ECE/TRANS/SC.3/2009/4
9 October 2009

**STANDARDIZATION OF TECHNICAL AND SAFETY REQUIREMENTS IN INLAND
NAVIGATION**

Amendments to European Code for Inland Waterways

Proposal submitted by the Chairman of the informal working group on
European Code for Inland Waterways

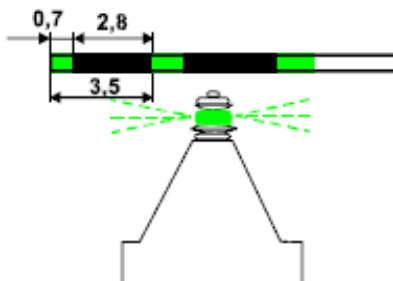
- (a) Figure 1: add an image of buoy with light and the following drawing for light

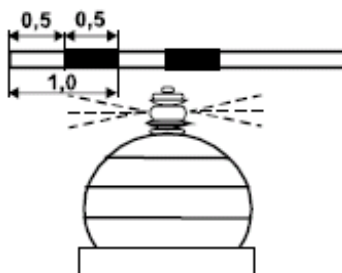
(a) Figure 2: add an image of buoy with light and the following drawing for light

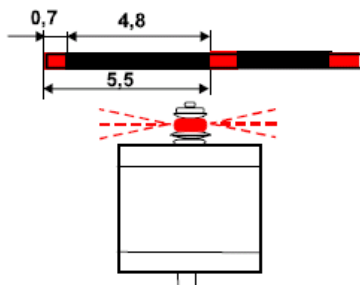
(a) Figure 3: add an image of buoy with light and the following drawing for light

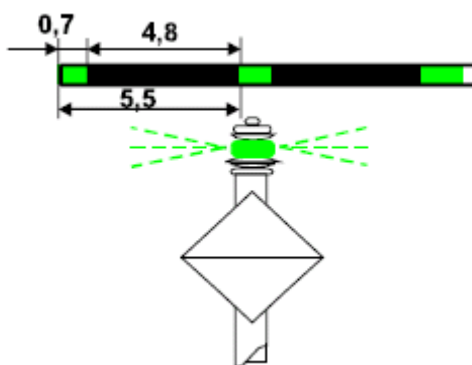
(a) In Figure 5, delete the second drawing

(b) In the paragraph on topmark delete or square frame (sides horizontal and vertical), painted red

(c) Add an image of the mark with light and the following drawing for light

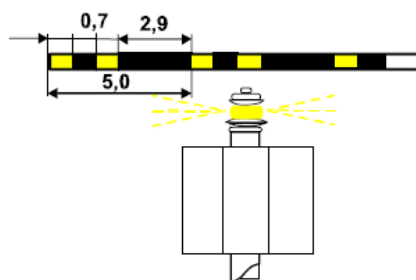
- (a) In Figure 6, delete the second drawing
- (b) In the paragraph on topmark delete or square frame (sides horizontal and vertical), painted green
- (c) Add an image of the mark with light and the following drawing for light

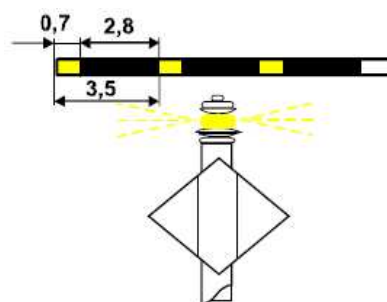
- (a) In Figure 8, delete the second drawing
- (b) In the paragraph on topmark delete or a lath-assembled St.George's Cross, painted yellow
- (c) Add an image of the mark with light and the following drawing for light
